ADDENDUM NO. #2

CITY OF PEORIA SIDEWALK AND CURB RAMPS, 2022 FEBRUARY 7TH, 2023 @ 2:00PM AT PEORIA PUBLIC WORKS

RE: **Addendum #2** for the Sidewalk & Curb Ramps, 2022 project

| SHEET | C301 | SHEET NO. | 14 | OF 42 SHEETS |

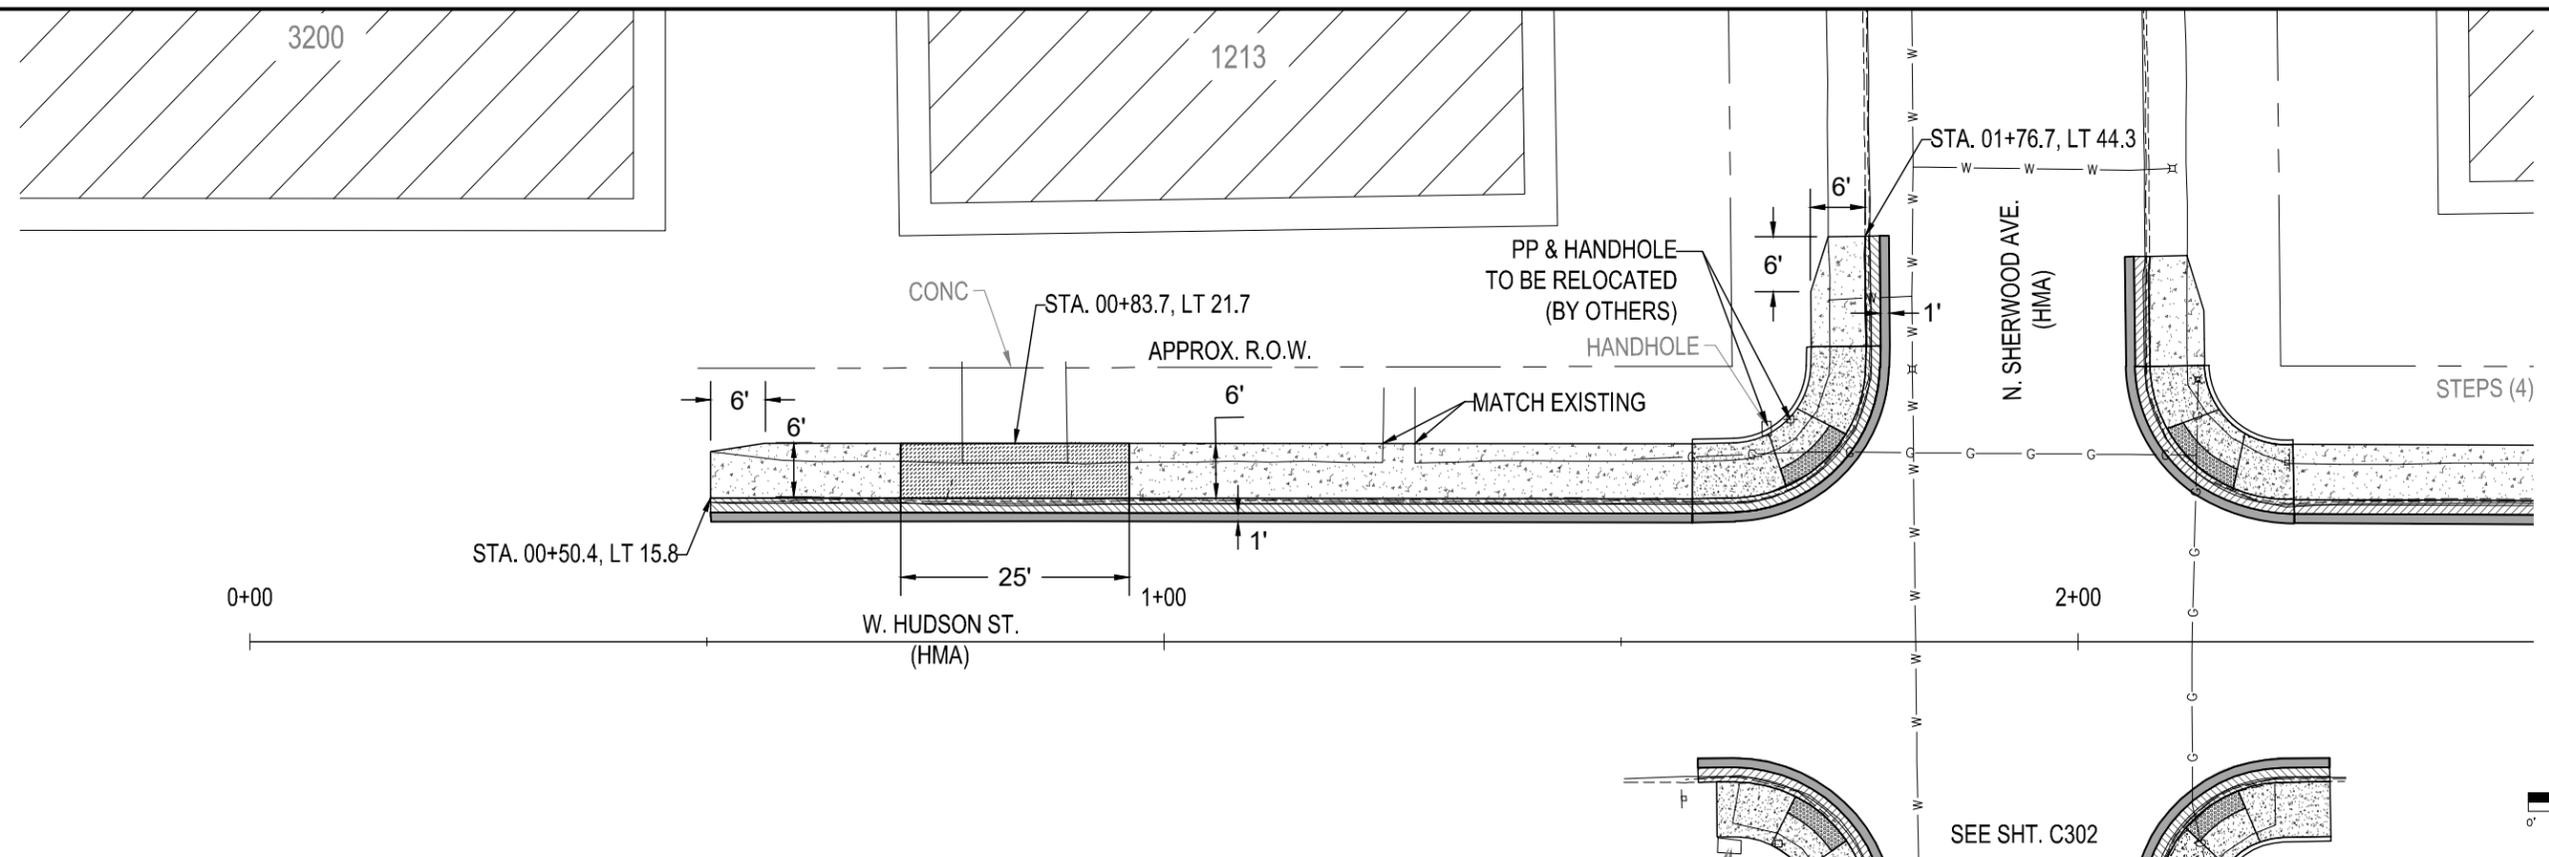
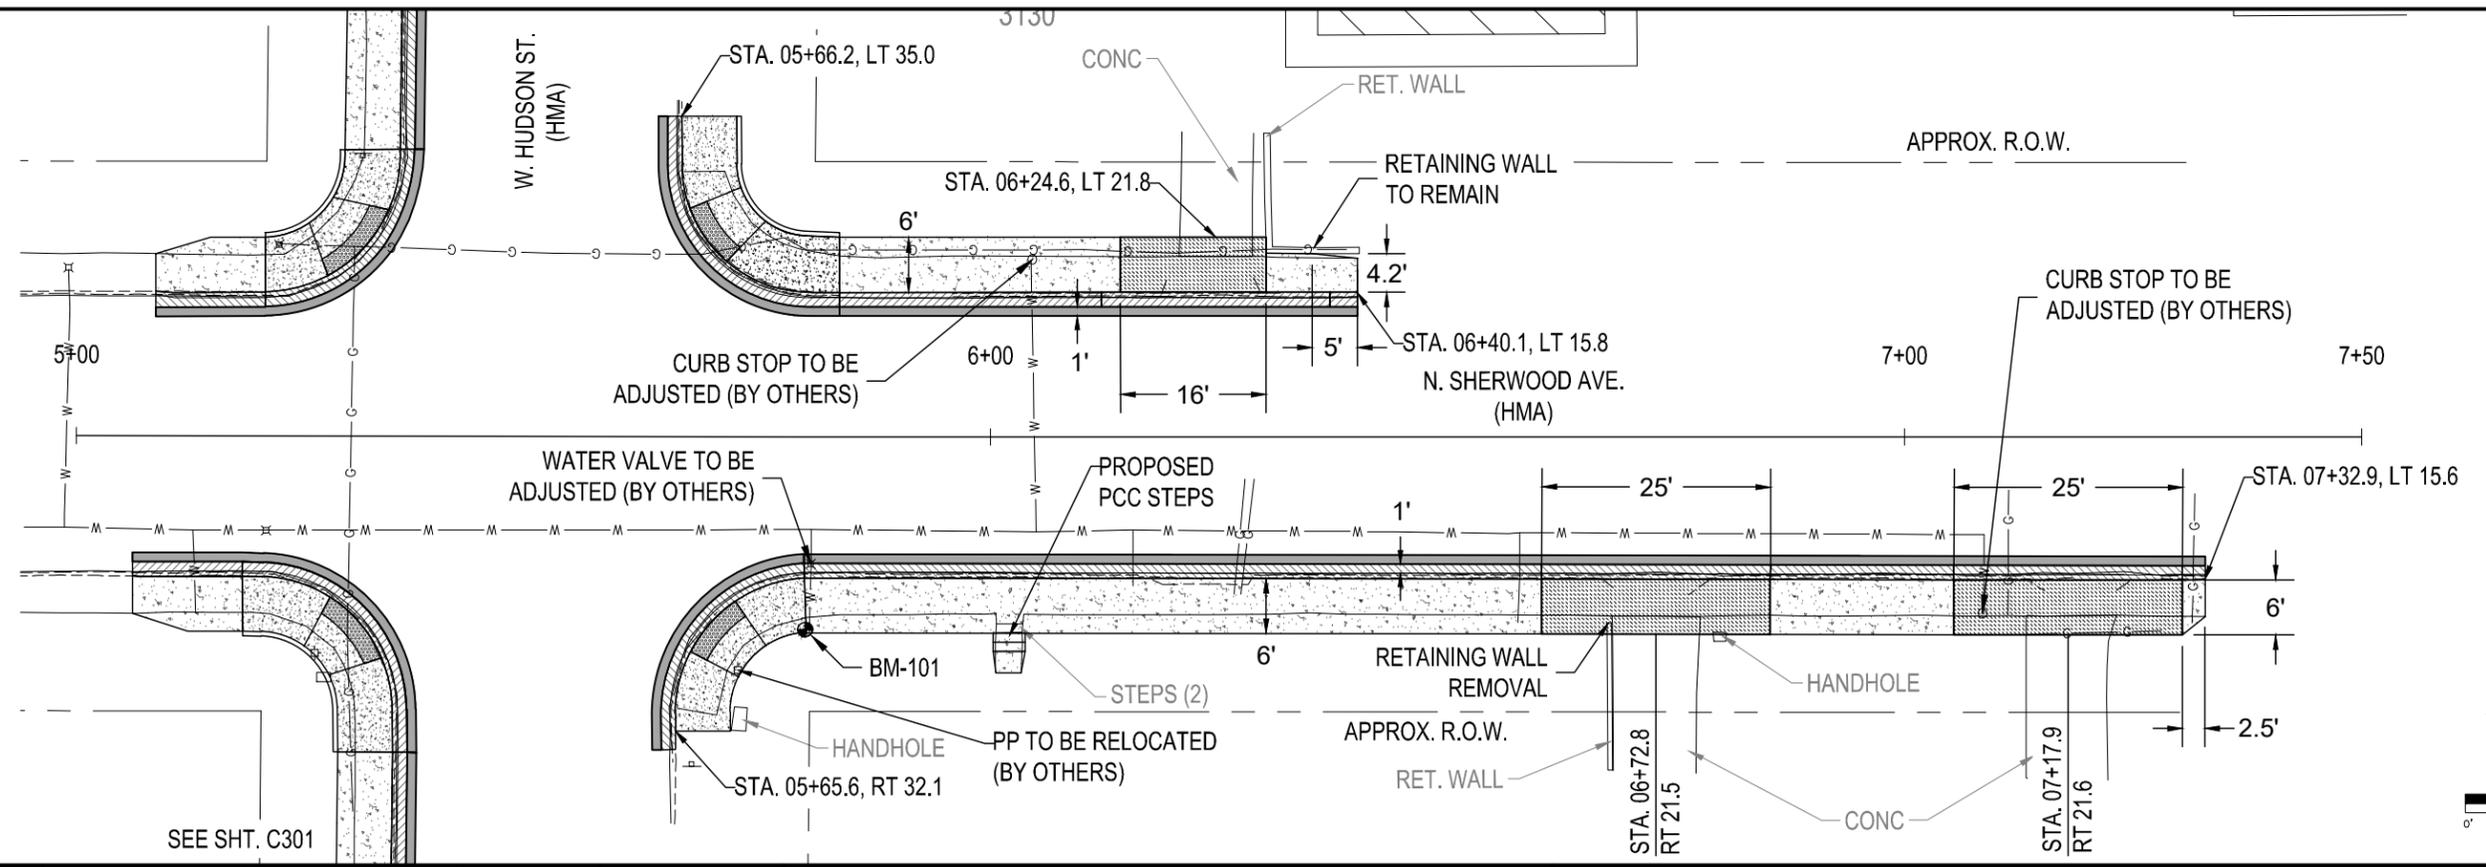
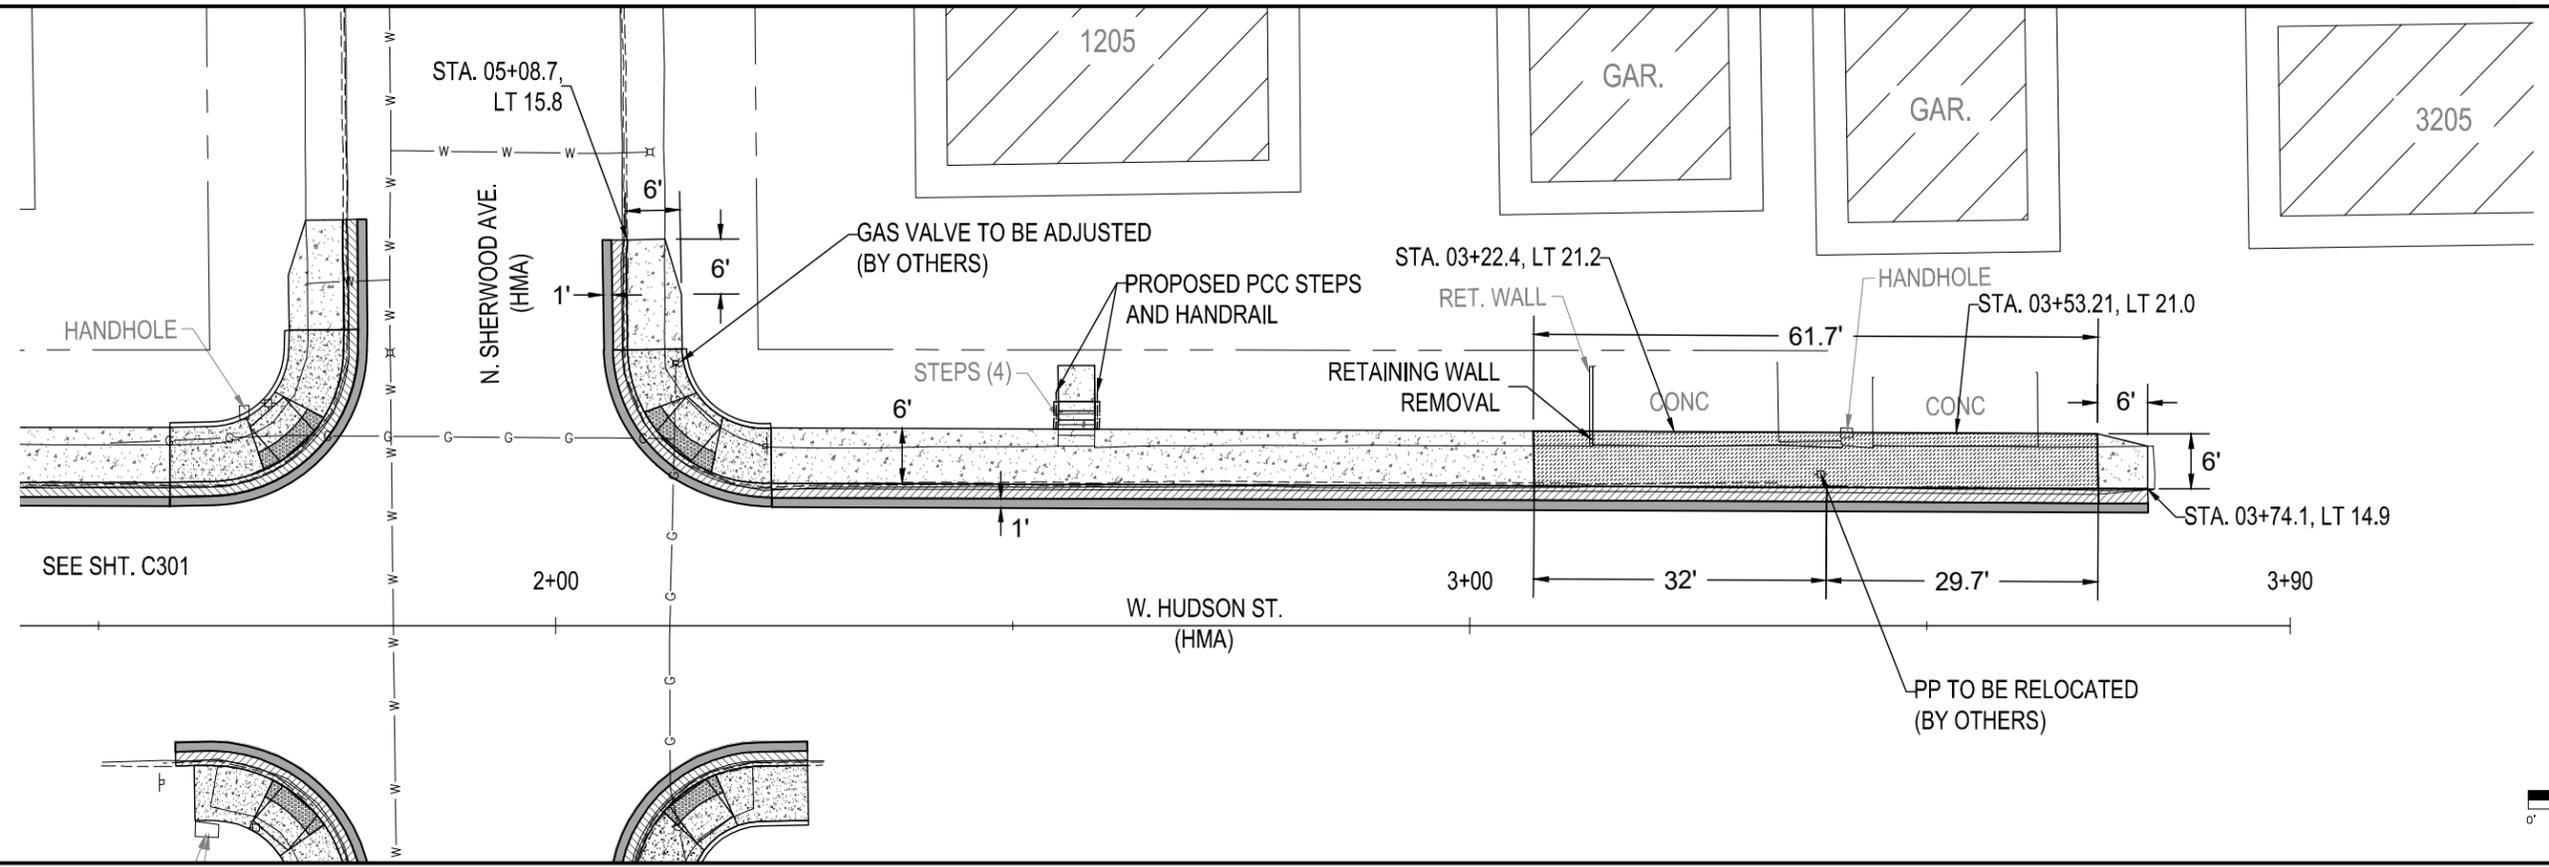
- 5) **Plans, Sheets 14-23: Plan sheets revised to provide clarity of Pavement Removal, Class D Patching, and Comb. Curb & Gutter pay limits at entrances (with buffer area between sidewalk and curb).**

2 INLET ADJUSTMENT DETAIL
N.T.S.

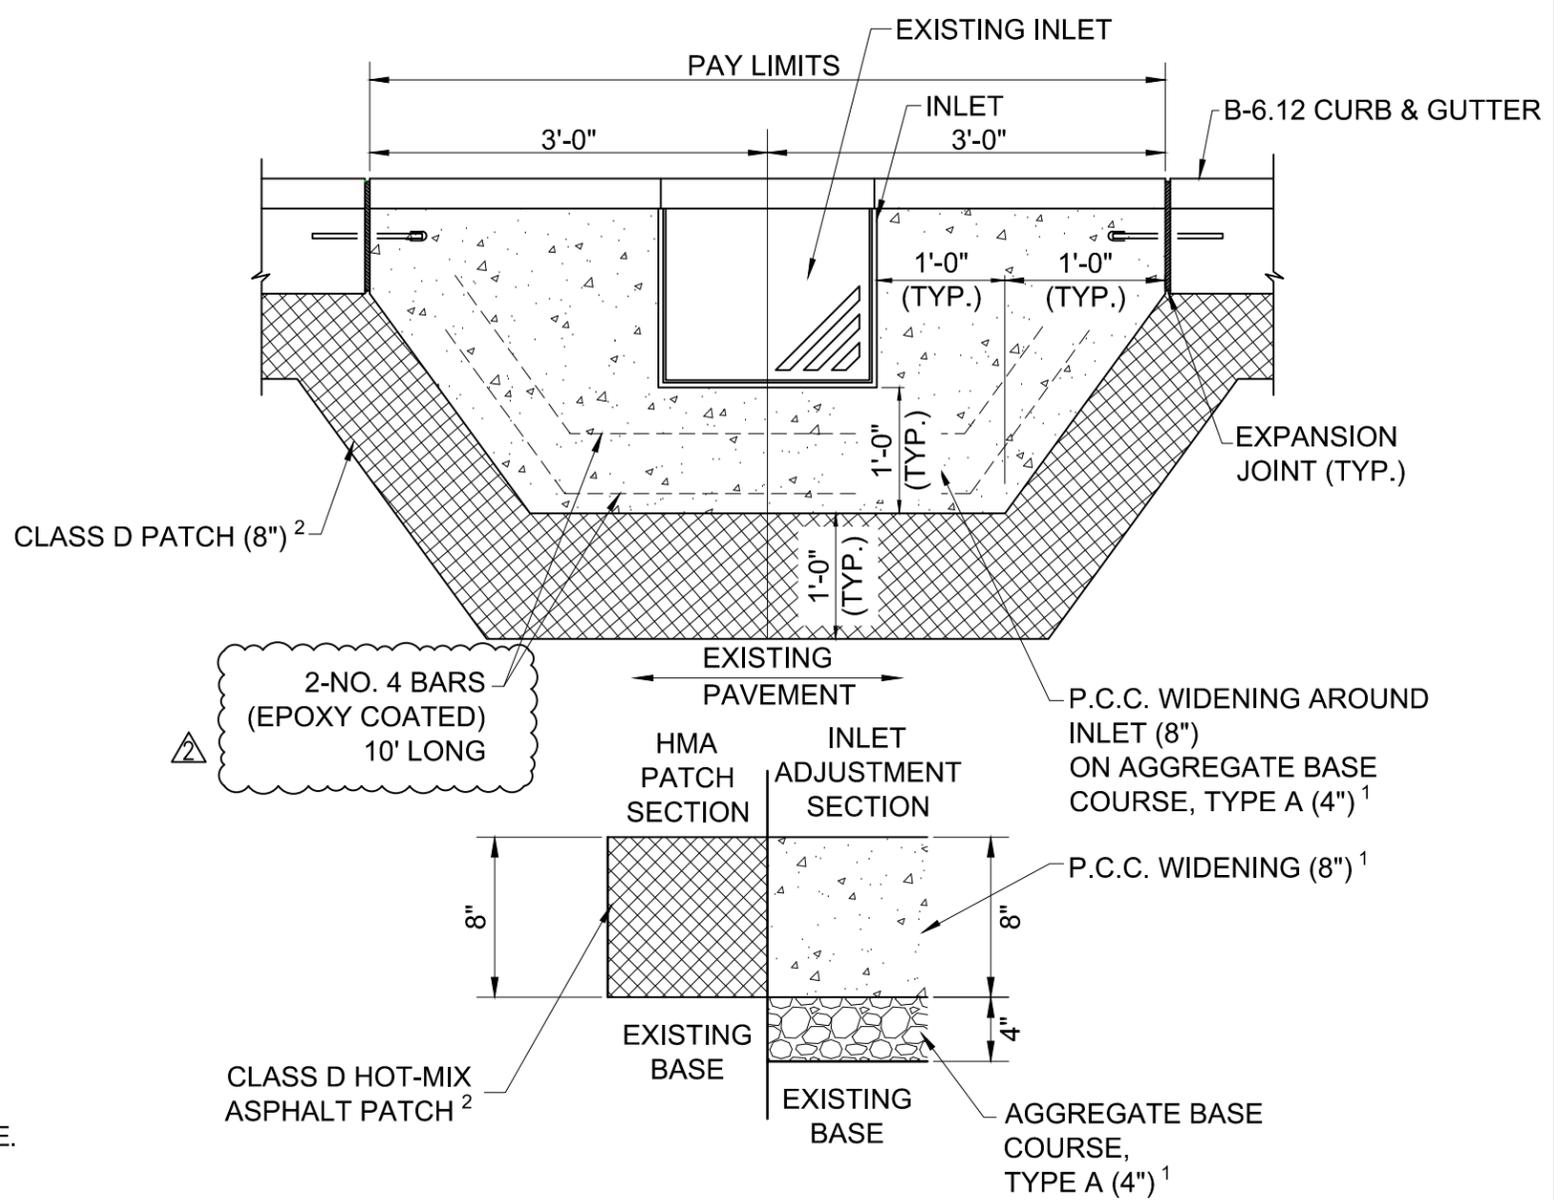
- 6) **Plans, Sheet #39: Reinforcement bars to be used in the *Inlets to be Adjusted (Special)* pay item, as shown in the “Inlet Adjustment Detail,” shall be epoxy coated.**

- 11) **Specifications, Page 66: Added “Reinforcement bars shall be epoxy coated and in accordance with Section 508 of the standard specifications” to the *Inlets to be Adjusted (Special)* special provision.**
